UX/UI FOR: GEODIS

Exercise 1

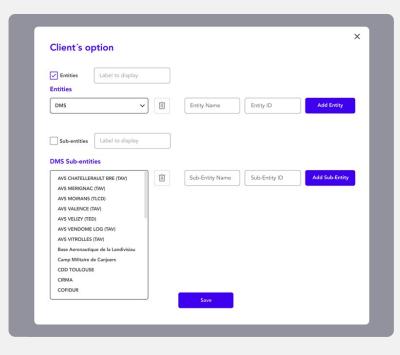
• There's no need for a checkbox. Users can click on the options if they want to use the *Entity* part, and if they want to use the *Sub-Entity* section, they need to select the *Entity* first, but no checkbox is required in this part either.

• It's better to have a label text above the text field and no placeholder. If they get interrupted while filling it out, users won't know what to type. It's ok to add additional content as a guide, but ensure that this explanatory information is placed outside the text field.

• Forms should be vertical not horizontal some users will see the form on a mobile phone, horizontal scrolling is unnatural, while vertical scroll is what user expects in both desktop and mobile.

• There's no need for a save button. When a client adds an *Entity* or *Sub-Entity*, it will be automatically saved. Similarly, when they delete them, the changes will also be automatically saved.

• Using asterisks is an effective method to indicate to users which fields are necessary. I suggest consolidating all the information. Some text displays 'Sub-Entity Name' where each word starts with a capital letter, while in other instances it says 'Sub-entities'.

Similarly, in the dropdown list, most of the *Sub-Entities* are in capital letters, but some are not.
